# Access Compliance Report Public Rights-of-Way (Curb Ramps)

Main Street: BLAKEMORE\_DR Cross Street: SIENNA\_PKWY Location: SE

ADA ID: RPRK211021143028 Ramp Type: Type 1 - Perpendicular Diagonal Initial Pass/Fail: Pass Overall Compliance: No Severity Score: 4

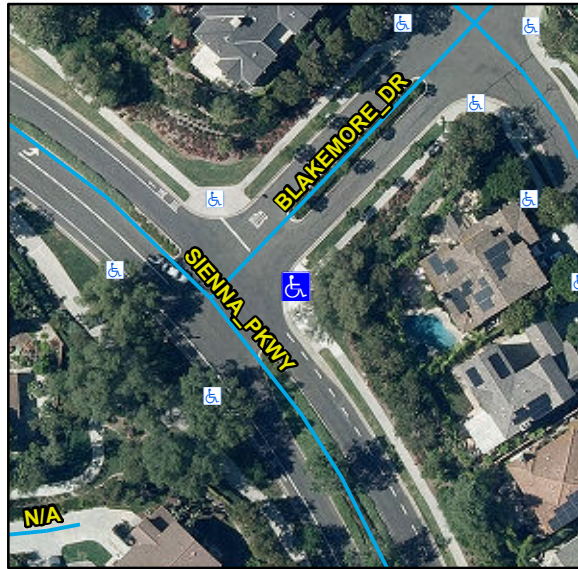
R304.2.1, STD 1115

Remove & Replace Landing.
